Thrumster Wastewater Scheme Objection

Figure 2-1 Daily rainfall for the Fernbank catchment (2015-16)

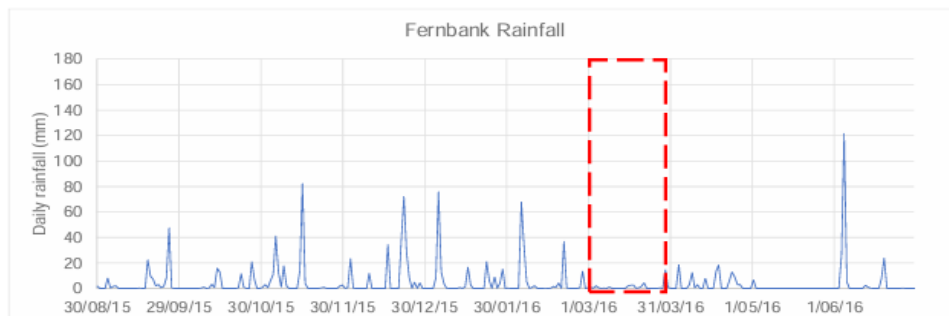
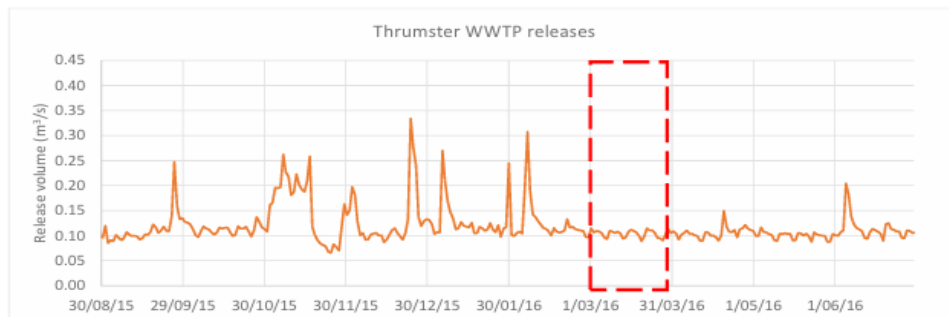
This analysis appears to rely on outdated data, using a dry-month scenario from records that are approximately nine years old I believe this is the best case scenario and modelling should have been based on worst case scenario with heavy rain periods to predict real water quality impact to the environment. More comprehensive modelling that considers recent climate trends and wet-weather events should be undertaken to ensure environmental integrity.

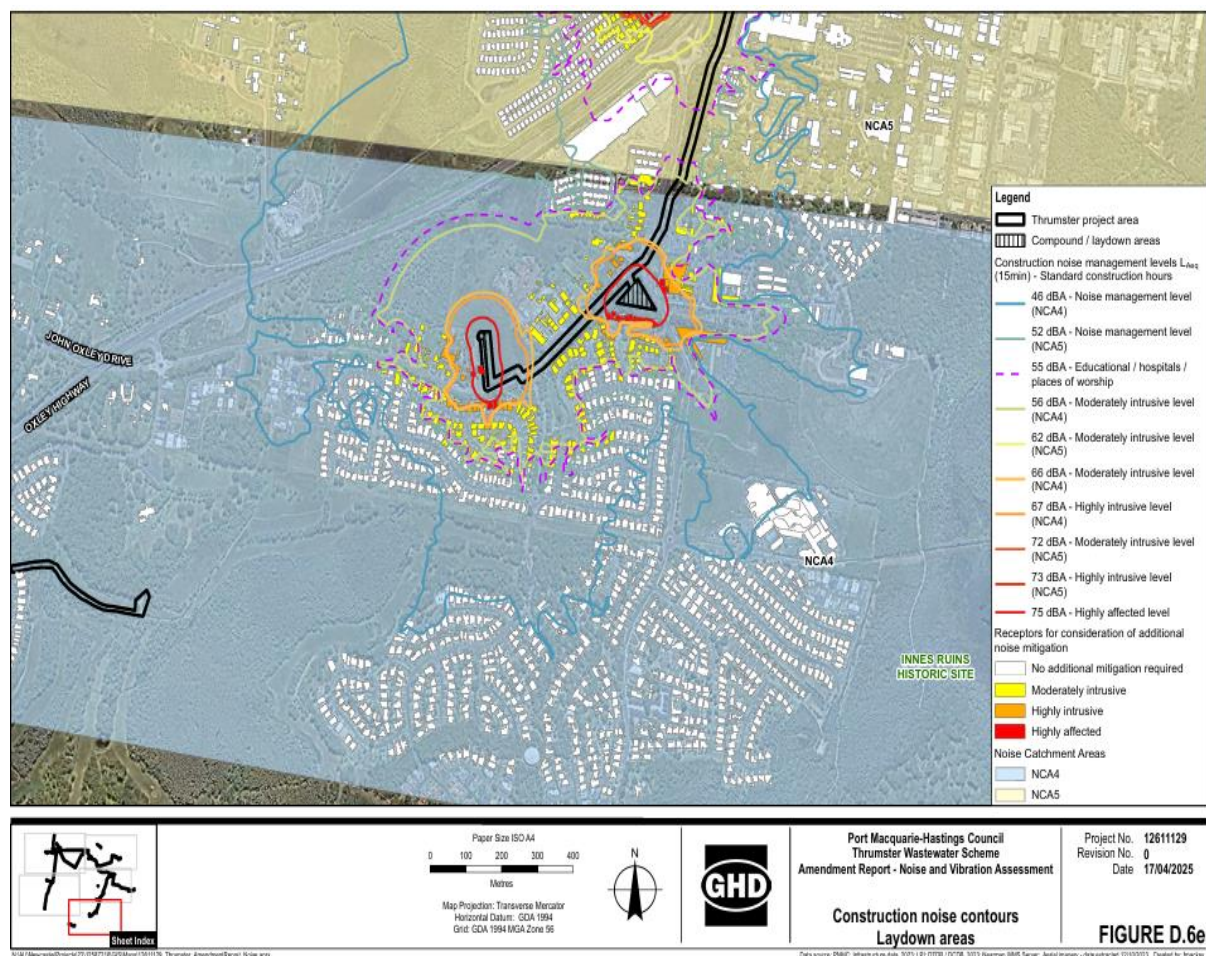
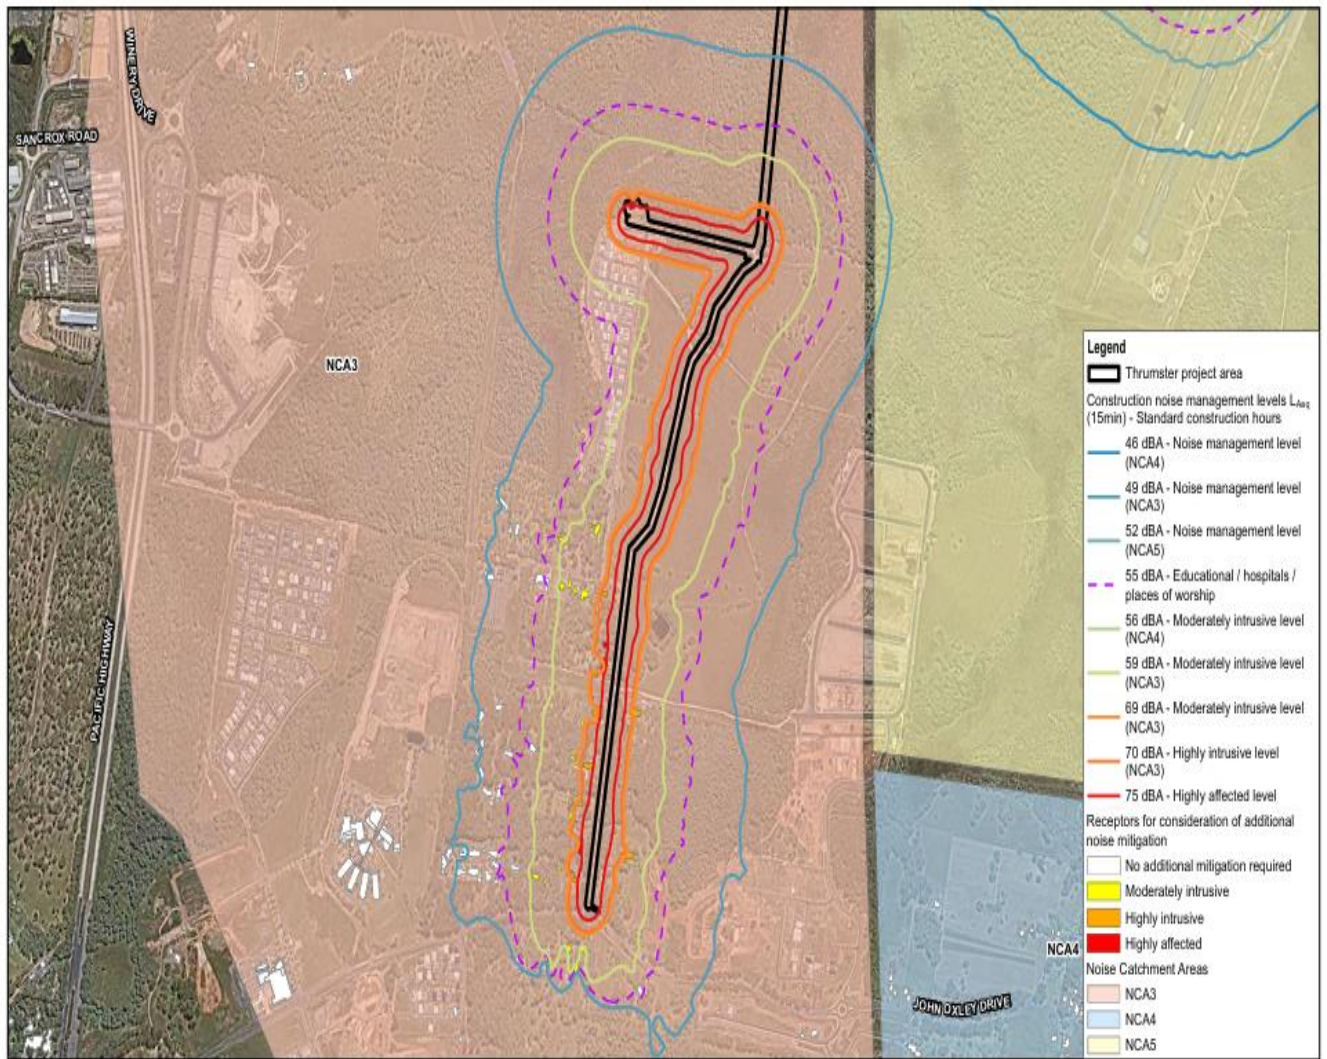
Appendix F of the Amended Report of Thrumster Wastewater Scheme contains critical data on highly impacted properties yet it appears placed at the very end from page 1399 to 1412, perhaps in the hope it would be overlooked by the uninformed impacted properties.

The maps provided in Appendix F maps (see below) are difficult to decipher due to omitted road names, making it unclear which properties will be affected. Improving transparency and accessibility of this information is essential to ensure impacted residents can properly assess the risks.

Table 24: Thrumster PAD 1 (AHIMS ID# 30-3-0390) artefact detail

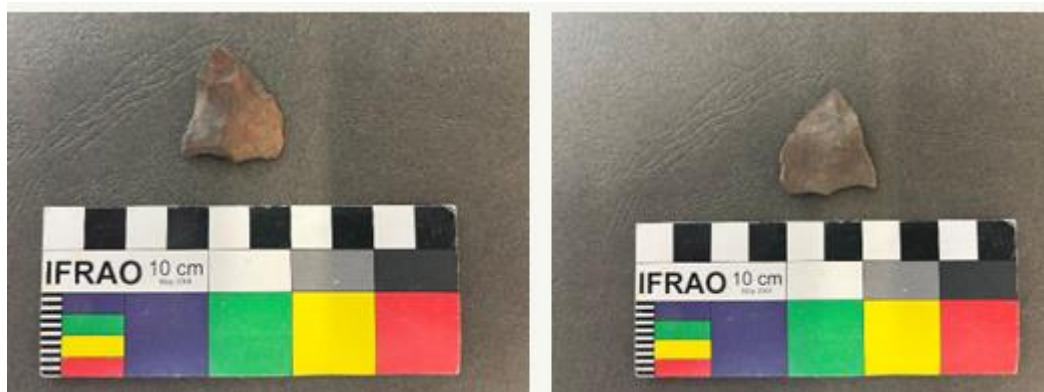
38 Artefacts found 1 I believe was museum quality see attached

Poor visibility of 10-20 %(above) indicates this study may not been conducted thoroughly, (see Niche Report)- This suggests that **80–90% of potential artefacts may not have been identified**, raising concerns about whether cultural heritage protections were adequately upheld. The **poor survey visibility** warrants a more thorough assessment.
